CALL NO. 111
CONTRACT ID NO. 141211
ADDENDUM # 2

Subject: Christian County, NHPP 0411 (017)
Letting March 28, 2014

(1) Revised - Plan Sheets - R11, X13, X14, & X15

EDWARD T. BREATHITT PARKWAY
U.S. 41A PLAN
STA. 41+00 TO STA. 47+00

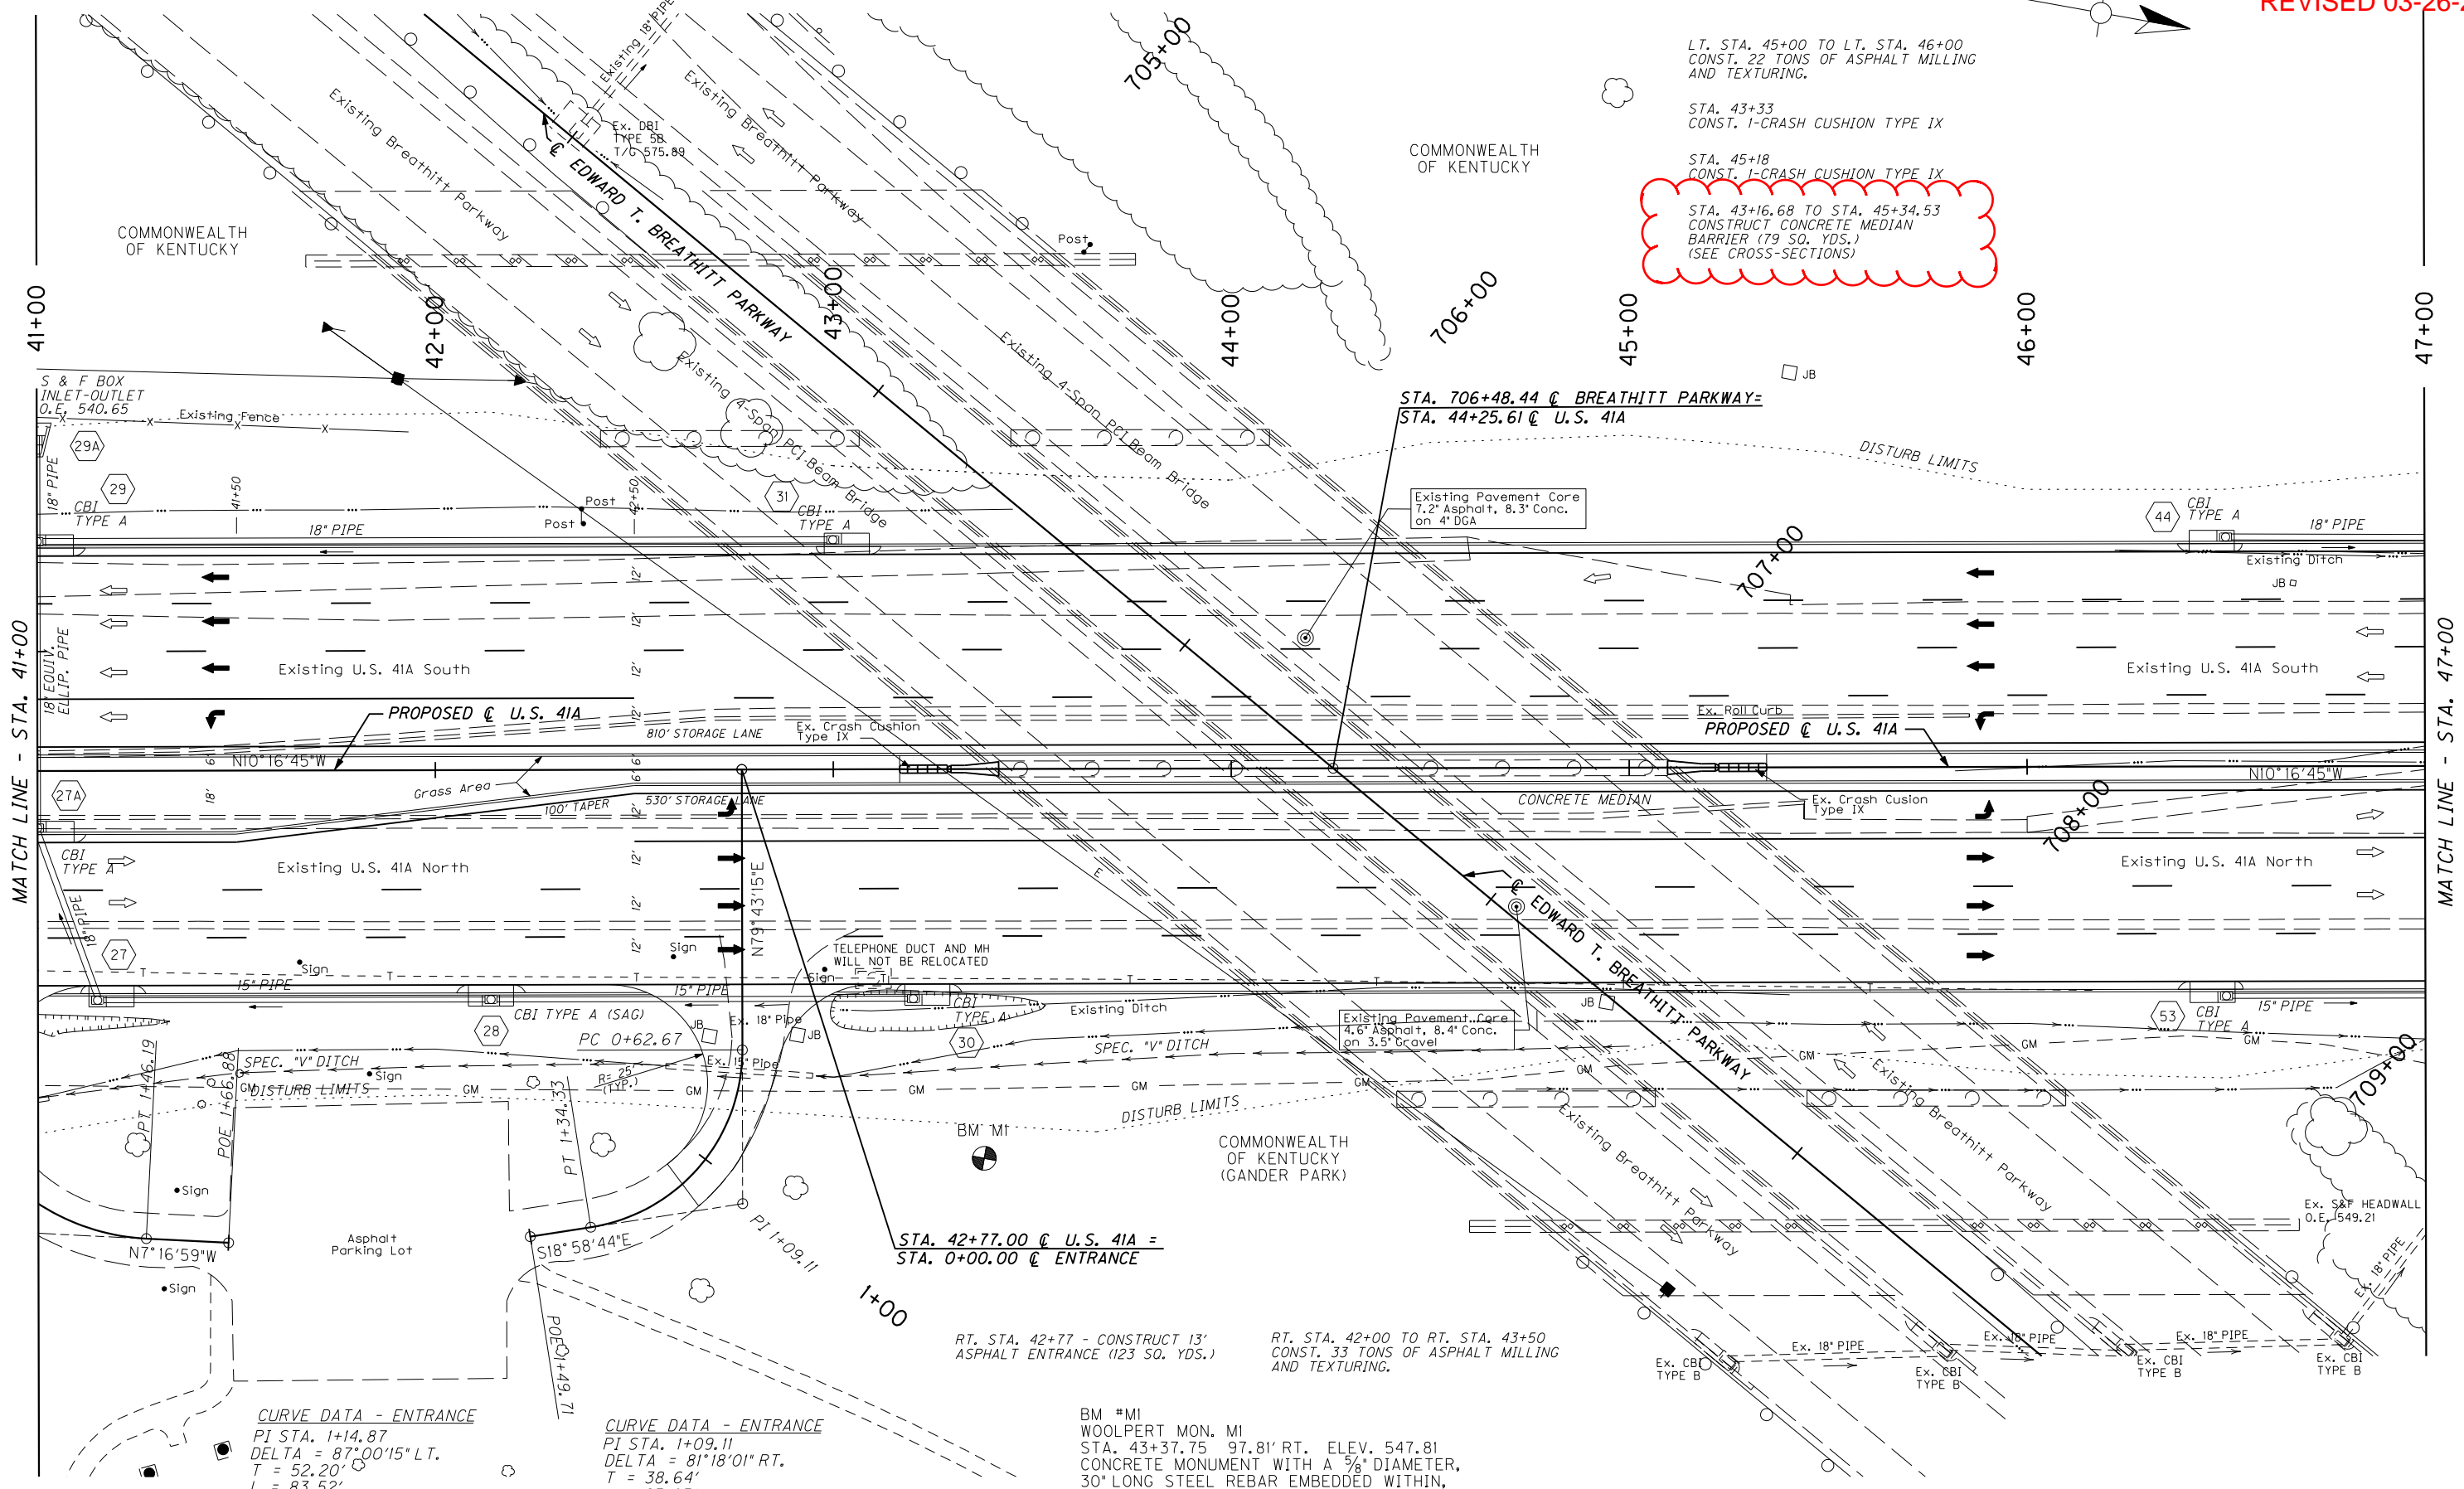
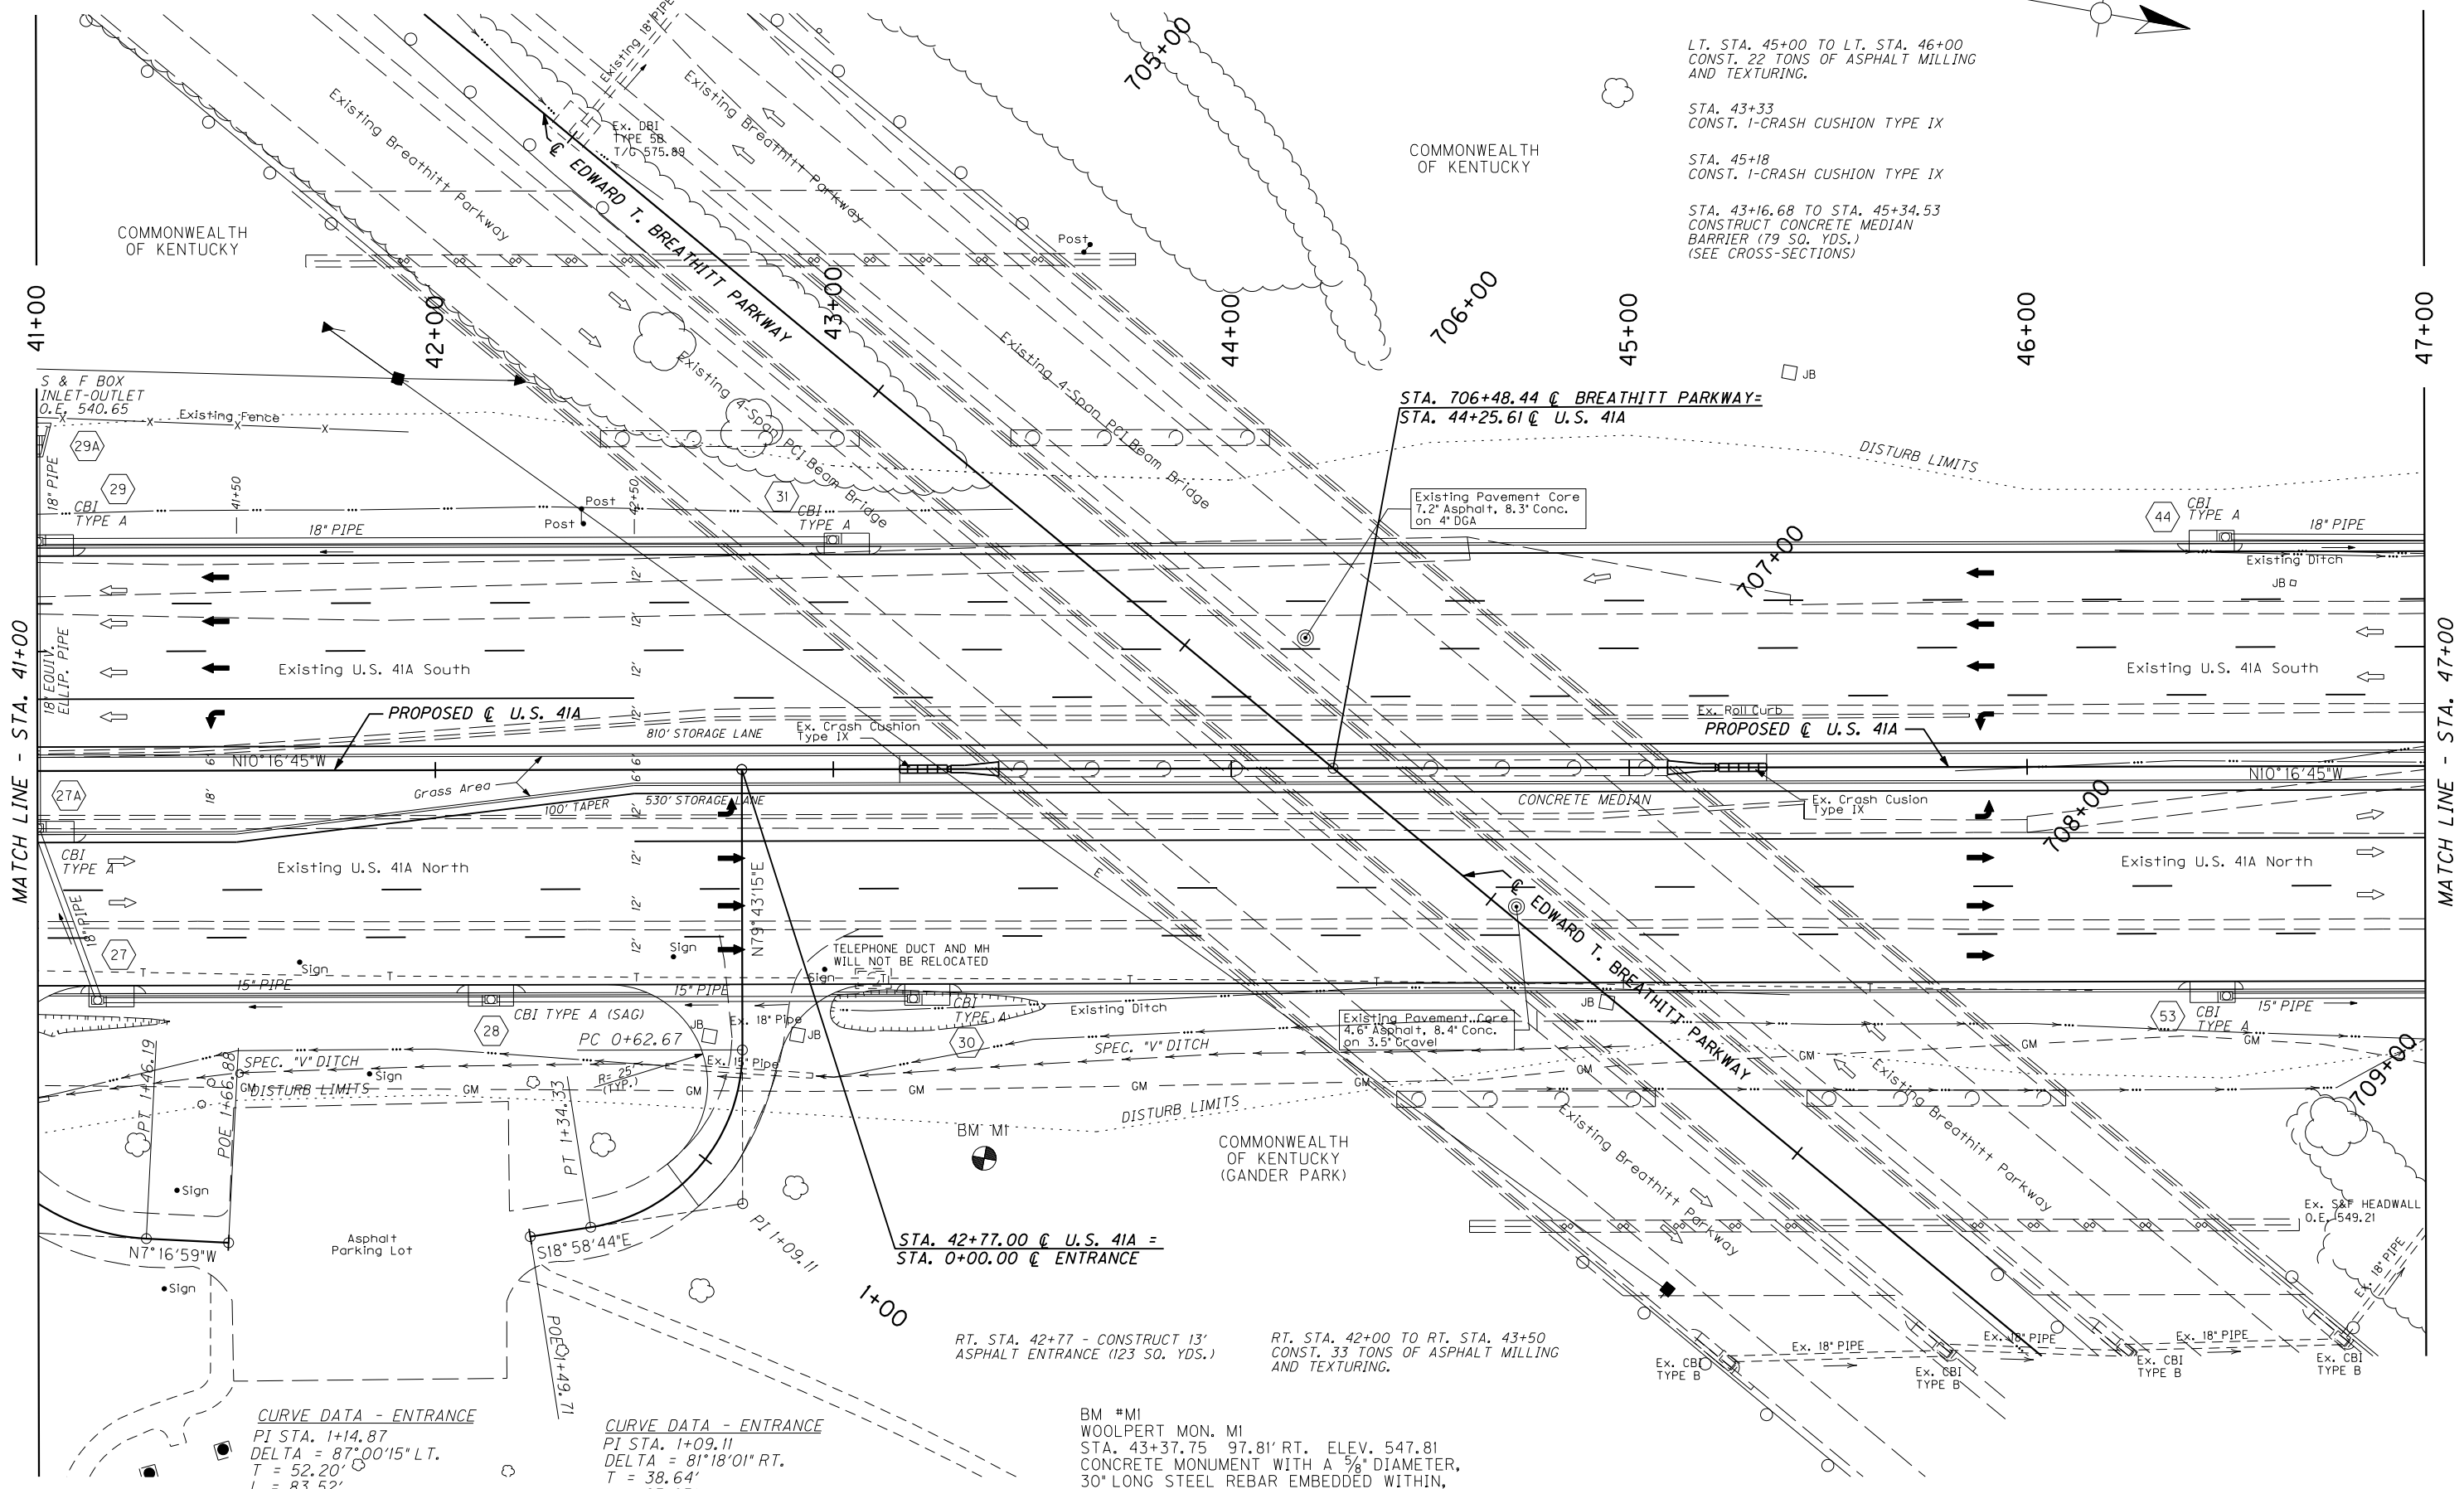
STA. 43+16.68 TO STA. 45+34.53
CONSTRUCT CONCRETE MEDIAN
BARRIER (79 SQ. YDS.)
(SEE CROSS-SECTIONS)
